Central Valley Clean Water Association

Re: Comments on the Tentative Order for the City of Galt Wastewater Treatment Plant and Reclamation Facility

Attachment 1
Comments Regarding Tentative Order for City of Galt WWTP
Submitted by the Central Valley Clean Water Association
August 9, 2010

Figure 1: Schematic of Receiving Water with Discharge of Higher Hardness and Metals Criteria for a Concave Down Metal (Copper).

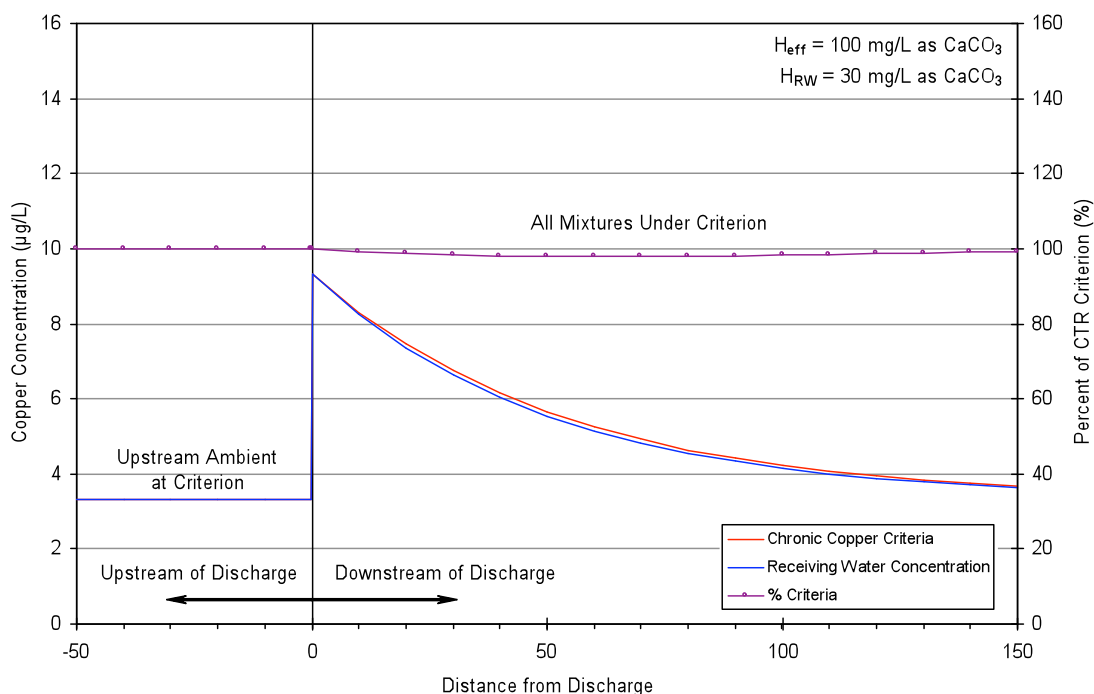
schematic in Figure 1 for the case of upstream hardness less than effluent hardness. If the upstream ambient copper concentration is at the CTR criterion, there is no assimilative capacity as the water column is 100% of the CTR criterion. If the discharge is at the CTR criterion based on effluent hardness, then the receiving water at the end of pipe will equal the effluent hardness and metals concentration; and the receiving water will be at 100% of the CTR criterion. As the hardness and metals in the receiving water and effluent mix, the receiving water downstream of the discharge will be below the CTR criterion due to the concave down shape of the criteria curve.

Figure 2: Schematic of Receiving Water with Discharge of Lower Hardness and Metals Criteria for a Concave Down Metal (Copper).

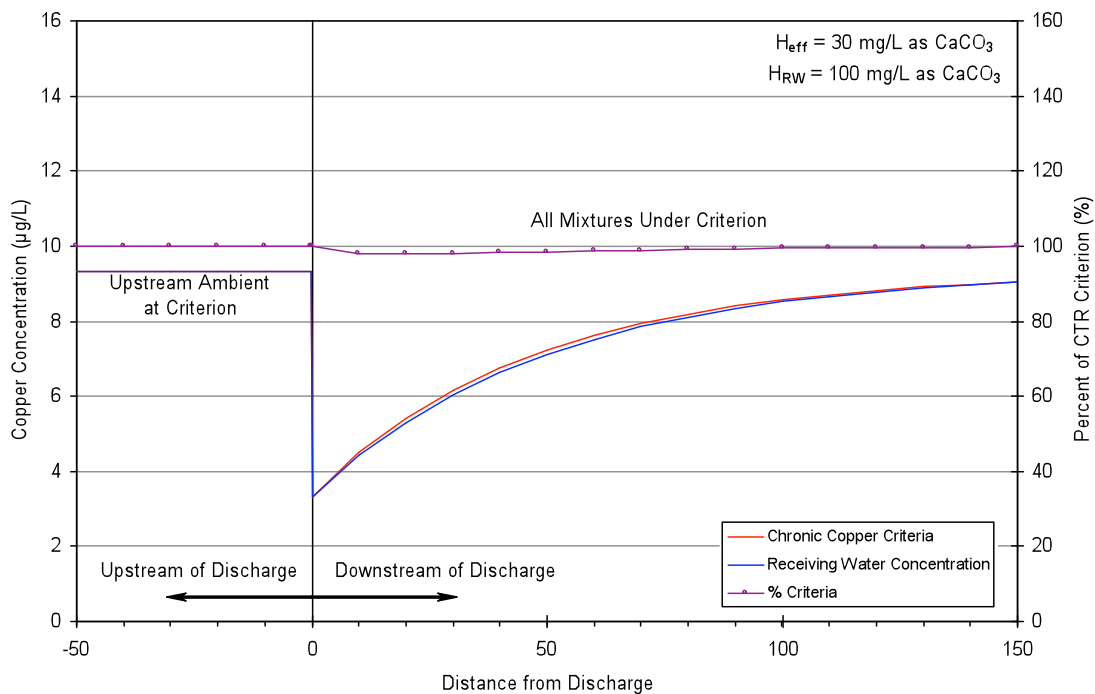
The schematic for the case of receiving water hardness greater than the effluent hardness is presented in Figure 2. The upstream ambient and at the point of discharge are at the CTR criterion and all mixtures of effluent and receiving water are below the CTR criterion.

Figure 3: Schematic of Receiving Water with Discharge of Higher Hardness and Metals Criteria for a Concave Down Metal (Copper). Upstream Ambient Above CTR Criterion and Effluent at 0.0 µg/L.

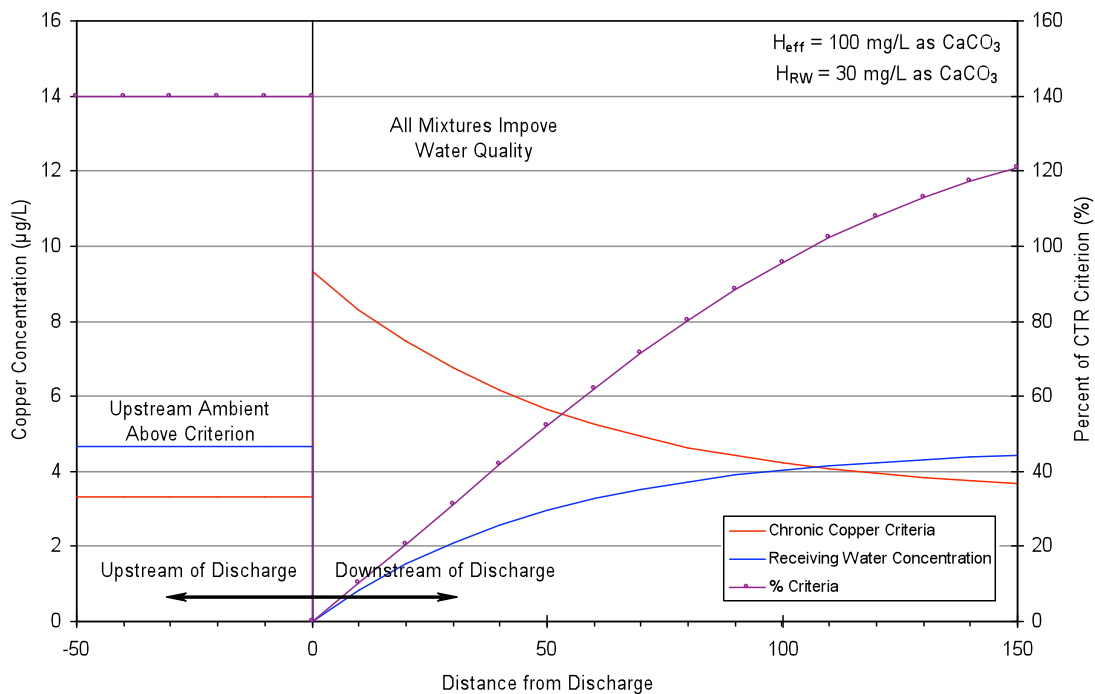
For the condition where the upstream ambient metal concentration exceeds the CTR criterion based on upstream ambient hardness, similar schematics may be constructed. Figure 3 is a schematic of the condition where the upstream ambient hardness is less than the effluent hardness, the upstream ambient copper concentration is 140% of the CTR criterion, and the effluent concentration of copper is $0.0 \mu\text{g/L}$. For the scenario displayed in Figure 3, the upstream receiving water is at 140% of the CTR criterion and right at the point of discharge the receiving water is at 0% of the CTR criterion due to the assumed $0.0 \mu\text{g/L}$ in the effluent. As the effluent and receiving water mix downstream of the discharge, the water quality is improved from the upstream condition. The clean effluent is diluting the upstream ambient. However, as the plume moves downstream with increased mixing and the percent effluent decreases, the copper concentrations increase as there is more upstream ambient represented in the water column. Depending on the flow ratios, the concentration in the receiving water downstream of the discharge may increase to be greater than the CTR criterion strictly due to the influence of the upstream ambient. For the case represented in Figure 3, the effluent is not causing or contributing to a receiving water exceedance of a water quality standard. All mixtures of effluent and receiving water have improved water quality over the upstream ambient, but the downstream mixtures may exceed CTR criterion solely due to the high level of metal in the upstream ambient.

Figure 4: Schematic of Receiving Water with Discharge of Higher Hardness and Metals Criteria for a Concave Down Metal (Copper). Upstream Ambient Above CTR Criterion and Effluent CTR Criteria Calculated with Upstream Ambient Hardness Level.

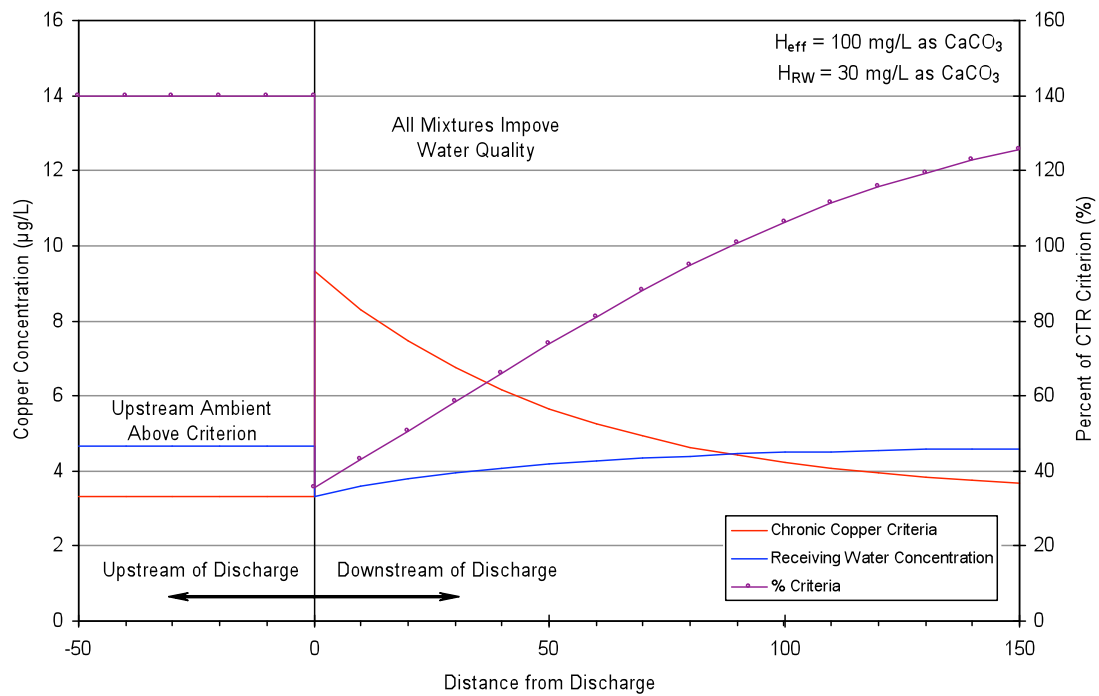
A similar schematic may be constructed for the case of upstream ambient exceeding the CTR criterion with the effluent concentration equal to the CTR criterion calculated with the upstream ambient hardness level, as is presented in Figure 4. Upstream of the discharge the receiving water is assumed to exceed the CTR criterion calculated from the upstream ambient hardness. At the point of discharge the effluent is assumed to equal the CTR criterion based on the upstream ambient hardness. As with the case with no copper in the effluent, mixtures with sufficiently high ratio of upstream water exceed the CTR criteria solely due to the levels of metal in the upstream ambient. All mixtures of the effluent and receiving waters have improved water quality compared the upstream ambient. For the case of effluent metals concentration equal to the CTR criterion based on upstream ambient hardness levels, the effluent is not causing or contributing to a receiving water exceedance of a water quality standard.

Figure 5: Schematic of Receiving Water with Discharge of Higher Hardness and Metals Criteria for a Concave Down Metal (Copper). Upstream Ambient Above CTR Criterion and Effluent CTR Criteria Calculated with Effluent Hardness Level.

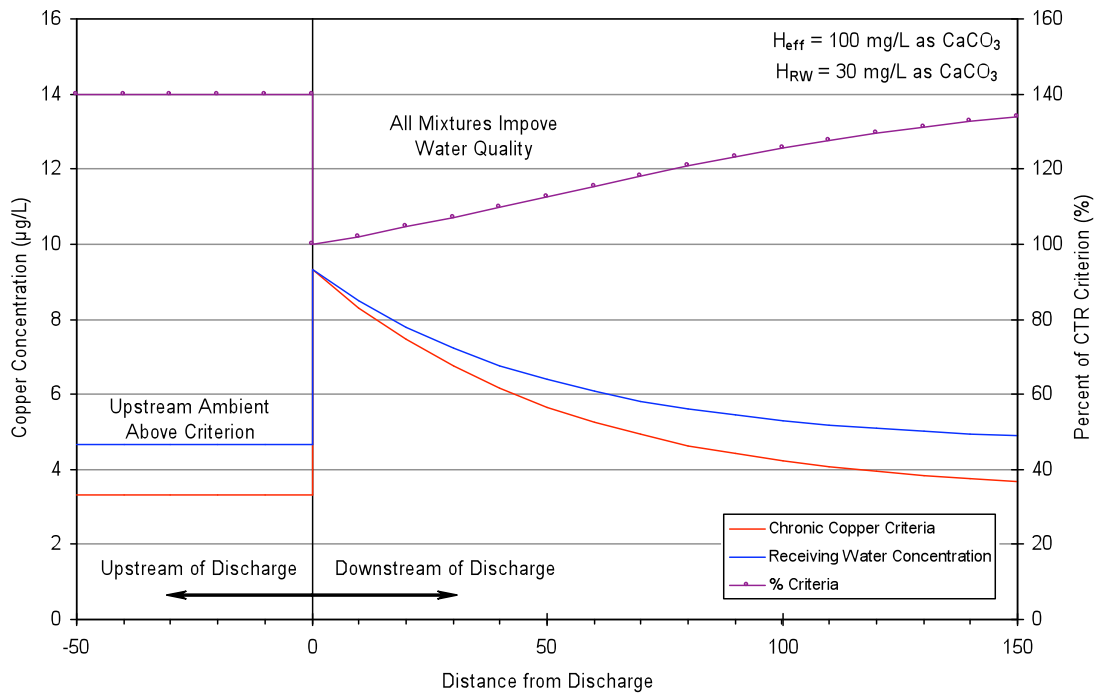
A schematic of the condition where the upstream ambient copper exceeds the CTR criterion and the effluent copper concentration equals the CTR criterion based on the effluent hardness is presented in Figure 5. In the case represented in the Figure, the upstream ambient exceeds the CTR criterion and at the point of discharge the receiving water equals the CTR criterion. For all mixtures downstream of the discharge the water quality is improved compared to the upstream ambient. For the case of effluent metals concentration equaling the CTR criterion calculated with the effluent hardness, the effluent is not causing or contributing to a receiving water quality standard.

Figure 6: Schematic of Receiving Water with Discharge of Lower Hardness and Metals Criteria for a Concave Down Metal (Copper). Upstream Ambient Above CTR Criterion and Effluent CTR Criteria Calculated with Effluent Hardness Level.

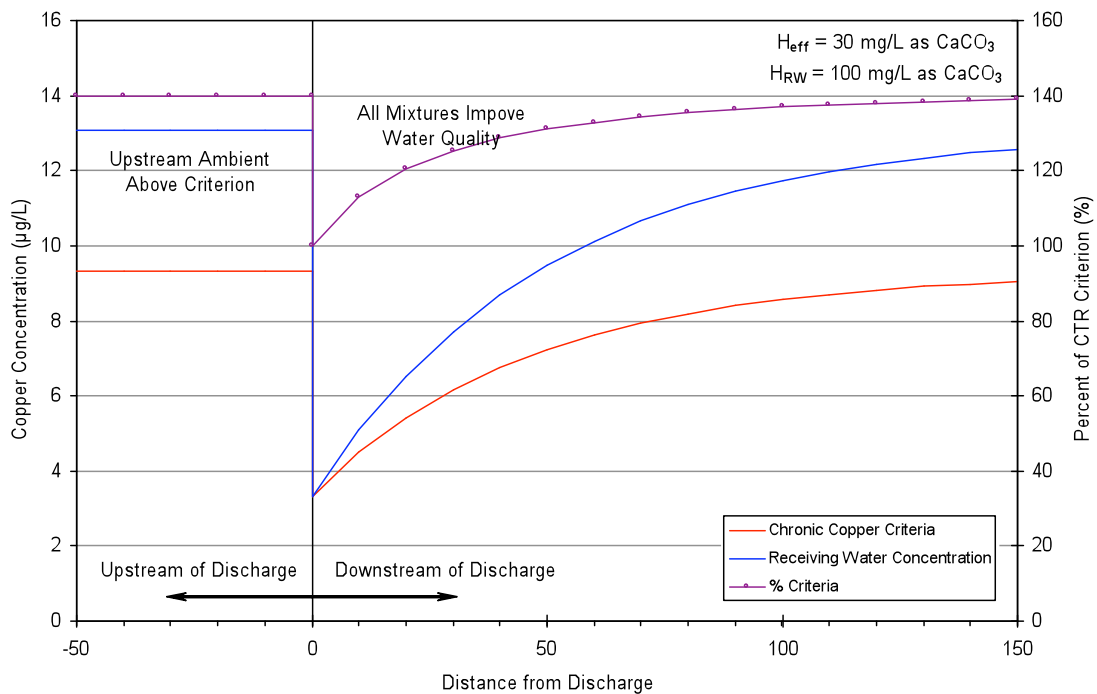
The case where the upstream ambient metal exceeds the CTR criterion and the effluent copper concentration equals the CTR criterion based on the effluent hardness and the upstream hardness is greater than the effluent hardness is presented in Figure 6. As with the case represented in Figure 5,

all mixtures of upstream ambient receiving water and effluent have improved water quality over the upstream ambient. The effluent is not causing or contributing to a receiving water quality standard.

Figure 7: Schematic of Receiving Water with Discharge of Higher Hardness and Metals Criteria for a Concave Up Metal (Lead).

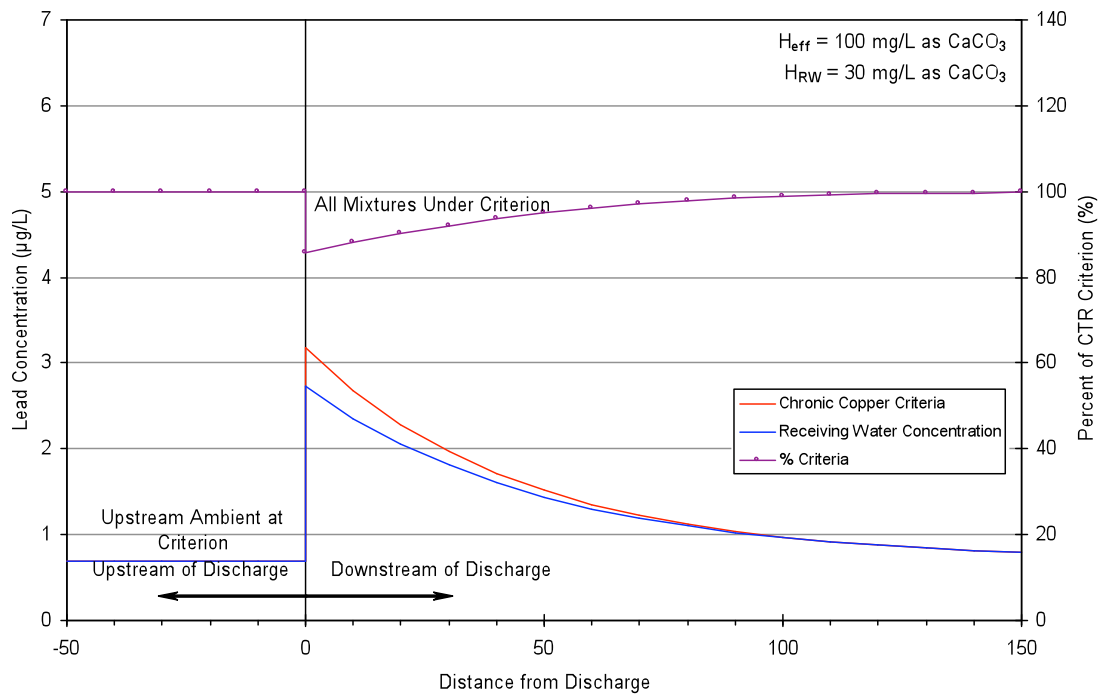
The schematic in Figure 7 corresponds to the case of the ambient concentration equal to the CTR criterion and effluent concentration equal to the value obtained from Equation (1) where the upstream ambient and effluent hardness concentrations are 30 mg/L as CaCO_3 and 100 mg/L as CaCO_3 , respectively. The upstream ambient concentration is at the CTR criterion and the discharge is slightly below the CTR criterion calculated from the effluent hardness. All mixtures of effluent and receiving water result in metals concentrations below the CTR criteria. Equation (1) provides the proper effluent criterion for the case where the effluent hardness is lower than the upstream ambient hardness as illustrated in Figure 8. For the case of upstream ambient at or below the CTR criterion, Equation (1) provides a criterion for the effluent so that any mixture of receiving water and effluent have metal concentrations below the CTR criterion.

Figure 10: Schematic of Receiving Water with Discharge of Higher Hardness and Metals Criteria for a Concave Up Metal (Lead). Upstream Ambient Above CTR Criterion and Effluent at CTR Criterion Calculated with Upstream Ambient Hardness Level.

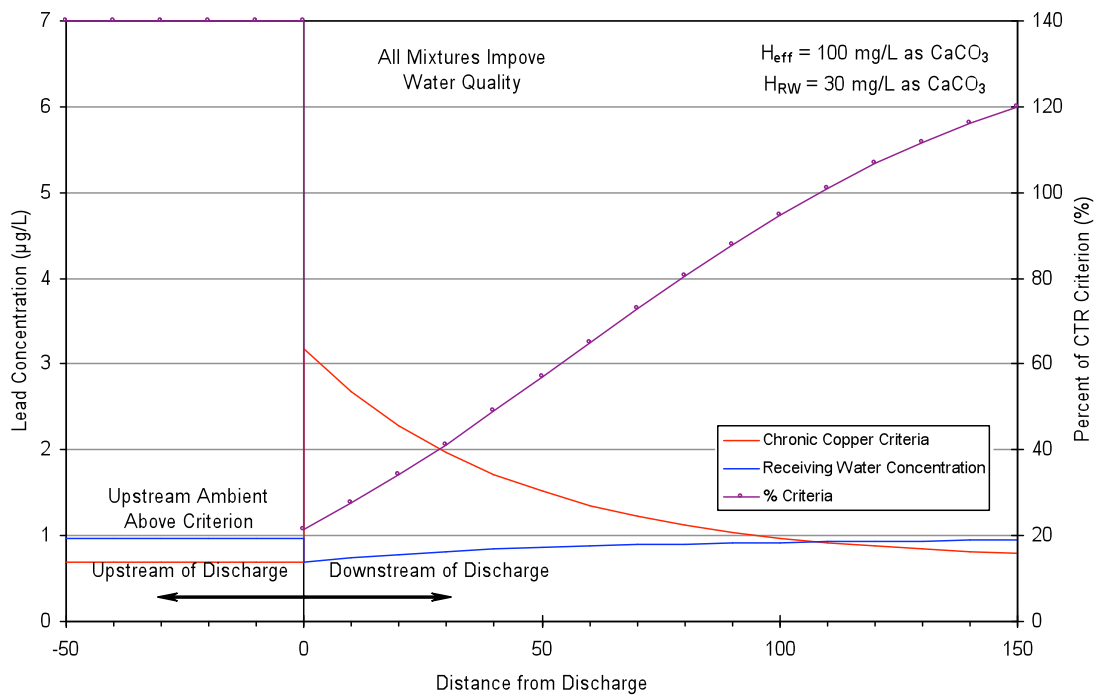
As is true for the concave down metals, specifying the effluent criterion as the CTR criterion calculated with the upstream ambient hardness results in all mixtures of effluent and receiving water with improved water quality from the upstream ambient case, as is illustrated in Figure 10. While depending on the flow ratios, some mixtures of effluent and receiving water may be above the CTR criterion, the water quality is improved over the upstream ambient condition. The effluent does not cause or contribute to an exceedance of the water quality standard.

Figure 11: Schematic of Receiving Water with Discharge of Higher Hardness and Metals Criteria for a Concave Up Metal (Lead). Upstream Ambient Above CTR Criterion and Effluent at CTR Criterion Calculated with Equation (1).

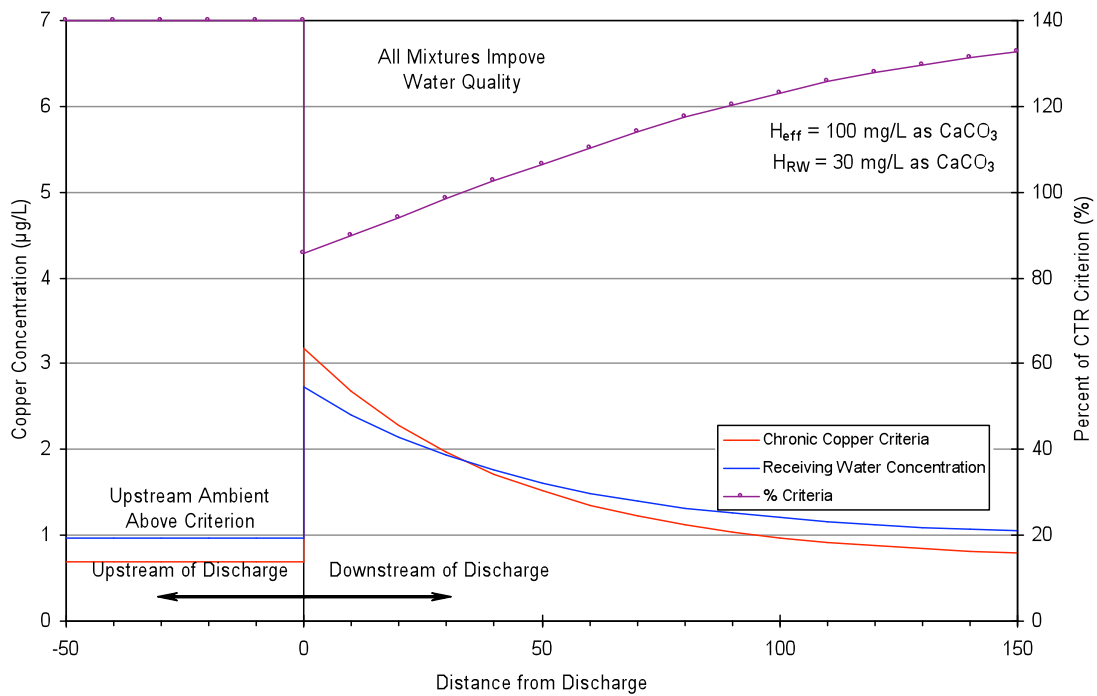
Calculating the effluent criterion with Equation (1) results in all mixtures of effluent and receiving water with improved water quality compared to the upstream ambient, as is illustrated in Figure 11. While depending on the flow ratios, some mixtures of effluent and receiving water may be above the CTR criterion, the water quality is improved over the upstream ambient condition. The effluent does not cause or contribute to an exceedance of the water quality standard. The result is the same if the upstream hardness is greater than the effluent hardness, as is presented in Figure 12.
